Subject: Response to Request for Additional Information Regarding Application for Steam Generator Tube Integrity Technical Specification

Response to Request for Additional Information Regarding Application for Steam Generator Tube Integrity Technical Specification Change

EXELON: Byron Unit 2 and Braidwood Unit 2
RESPONSE TO REQUEST FOR ADDITIONAL INFORMATION ON FP&L SEABROOK LICENSE AMENDMENT REQUEST 05-08 LIMITED INSPECTION OF THE STEAM GENERATOR TUBE PORTION WITHIN THE TUBESHEET (TAC NO. MC8554)

Figure 4: Sketch of Cracked Tube in Tubesheet leading to Leakage Flow-rate, Q_{OUT}. (Note that the gap shown between the tube and the tubesheet is for illustration purposes only.)

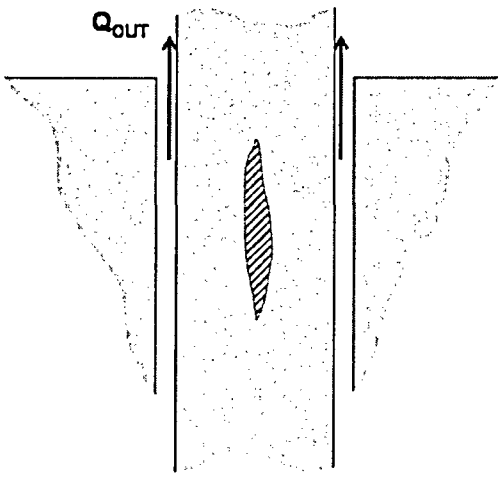
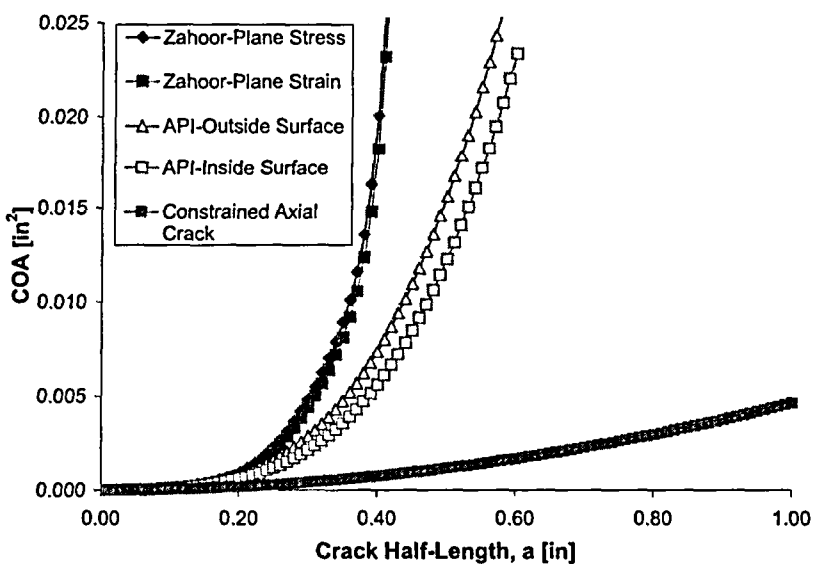
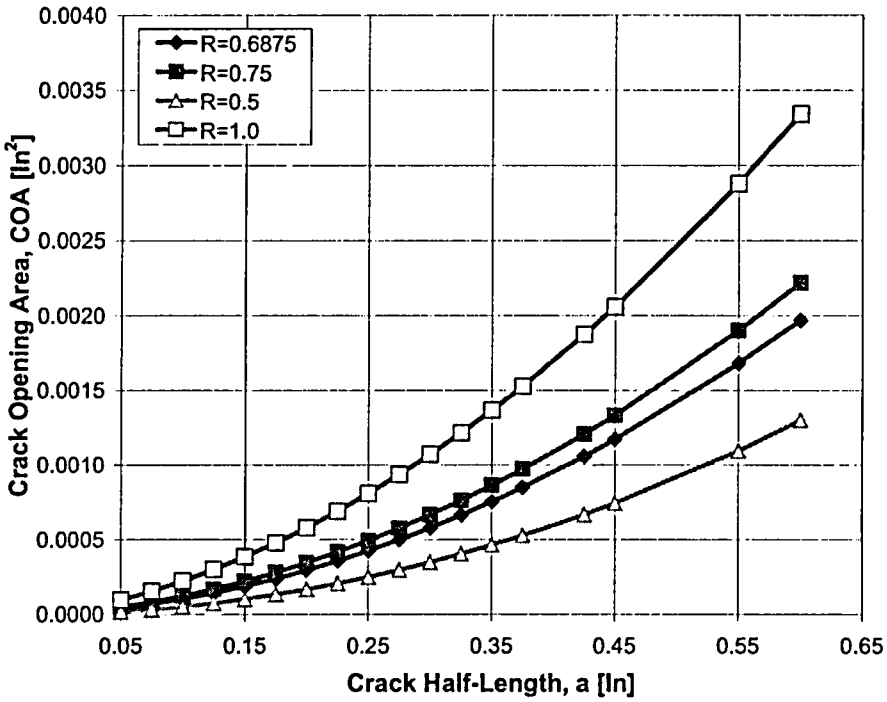
Under the proposed 17-inch tubesheet inspection zone, it is the Exelon's contention that the accident leakage integrity of the tubing below the 17-inch inspection zone is ensured by the bell-weather principle. The NRC staff requests that Exelon submit a leakage sensitivity study to support the conservatism of the bellwether approach. That is, leakage during accidents will not exceed two times that observed during normal operating conditions. The NRC staff requests that this study consider axial and circumferential flaws located at the bottom of the tubesheet at three tubesheet radial locations; i.e., at the zero radius, mid-radius, and peripheral locations. For each type of crack at each location, leakage under normal operating and accident conditions should be evaluated considering only the crack leakage resistance, considering only the tube to tubesheet annulus resistance and, lastly, considering the total resistance of the crack and annulus to leakage.

NRC RAI 6: The bellweather principle maintains that the increase in primary to secondary leakage when going from normal operating to accident conditions is bounded by a factor of 2. This is based, in part, on an assumed main steam line break (MSLB) and feed line break (MFLB) pressure differential of 2560 and 2650 psi, respectively, and a temperature of 600 degrees F. Provide the rationale which supports the conservatism of the 600 degree F assumption. This rationale should consider the time history of primary and secondary pressure and temperature during the accident. The staff's purpose in asking this question is ensure the time integrated leak rate is bounded by the bellweather principle factor of 2 increase relative to normal operating leakage. Provide the primary pressure and temperature curves as a function of time for the MSLB and MFLB accidents under consideration. Also, provide the rationale supporting the conservatism of the bellweather principle for a large break loss of coolant accident.

In trying to use the Westinghouse computer model to provide a qualitative demonstration of the veracity of the B* analysis, a significant potential shortcoming associated with the approach must be recognized. The crack flow leak rate model portion of the code was based on a freespan axial crack, not a crack with flanks constrained by the tubesheet hole. Thus, the crack opening area computation could be significantly biased. In order to perform the requested studies the code was modified as follows:

The new model for the axial crack opening that takes into account the guidance and constraint provided by the surrounding tubesheet is described in what follows. See Figure 1, below, for a sketch of the model configuration.

Using these models, a sensitivity study was performed which consisted of a series of analyses to demonstrate the conservatisms of the bellwether approach. These analyses considered the locations and conditions specified in the RAI, i.e., crack only, crevice only and combined crack and crevice.

The comparison above shows that the results for the new model, for a constrained internally pressurized tube, are reasonable in comparison to the other established models for unconstrained tubes. Specifically, the new model predicts a smaller crack opening area as a function of crack length than the unconstrained axial cracks with a smaller rate of increase in the crack opening area. This is an expected result because the other models assume a free span for the tube with no constraining effects. The COA should be come asymptotically linear with increasing length because the constraint from the tubesheet hole will restrict the opening to some maximum amount. Therefore, it is reasonable to use the new model for further calculations to estimate the crack opening area of a constrained and internally pressurized tube with a central axial crack.

The axial crack opening area results shown in the Figure 5 below are not directly indicative of the leak rate behavior during NOp and SLB conditions. However, the axial crack opening area is indicative of other factors that do regulate the leak rate. For instance, an increase in the crack opening area will decrease the potential leak resistance of the crack at NOp and SLB. However, this decrease in leak rate resistance due to the crack is comparable for both conditions; therefore, the leak rate ratio will remain relatively unchanged. The bellwether principle is still reasonable for various tube diameters with respect to the constrained axial crack opening area and the conclusions stated for the Model F steam generator tube size discussed above can be generically applied.
